ADDENDUM NUMBER TWO
TO PLANS AND SPECIFICATIONS
FOR
NEW COMPLEX FOR WASHINGTON COUNTY ROAD & BRIDGE
BRENHAM, TEXAS

October 23, 2018

PLANNORTH ARCHITECTURAL CO.

WALL CLARIFICATION SKETCH "A"

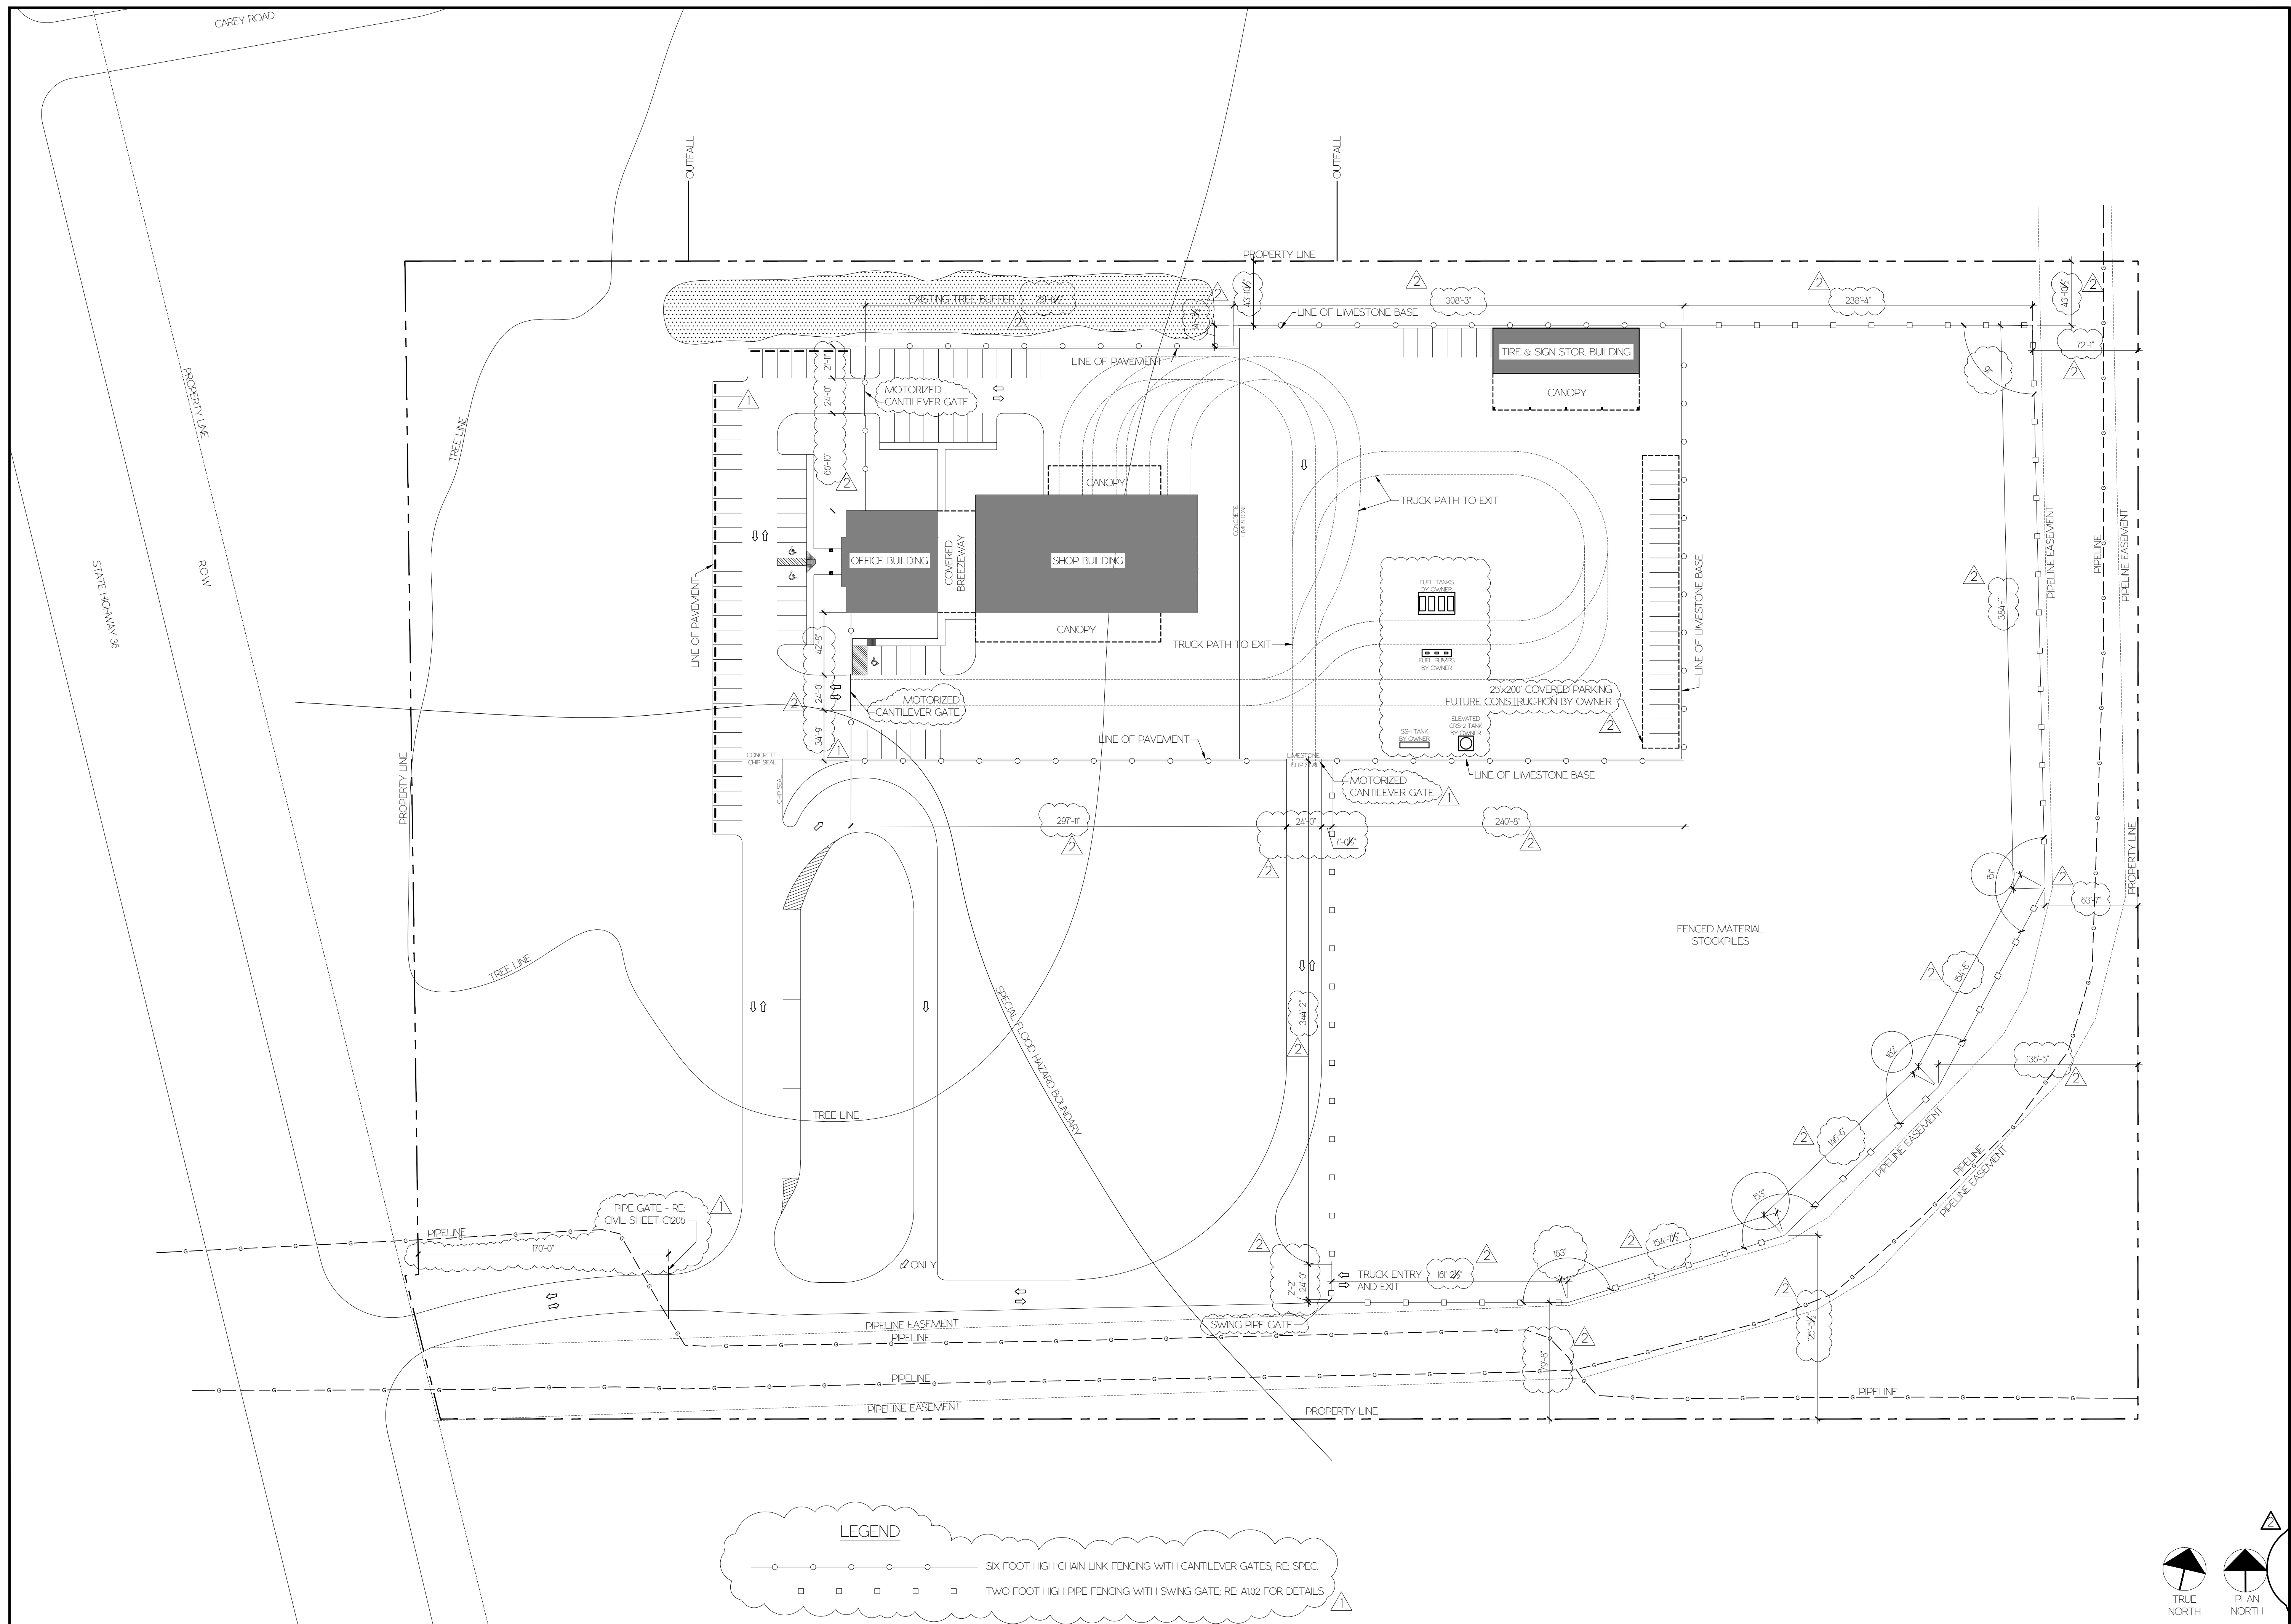
1. Please refer to the attached sketch A which clarifies which walls in the shop building receive rigid insulation. The walls highlighted pink have 6" metal studs + ½" fire retardant plywood or OSB sheathing + rigid insulation. Refer new wall section 3/A6.02. The walls highlighted yellow are typical in the shop and constructed as shown in Wall Section 3/A6.03.
2. The design load for the mezzanine is 125 psi per IBC 2015 Table 1607.1.
3. Allowances related to the site will not be carried in Base Bid A. Allowances related to the site will be included in Base Bid B.
4. Please provide a unit cost for casing of drilled piers. New Bid Form attached.
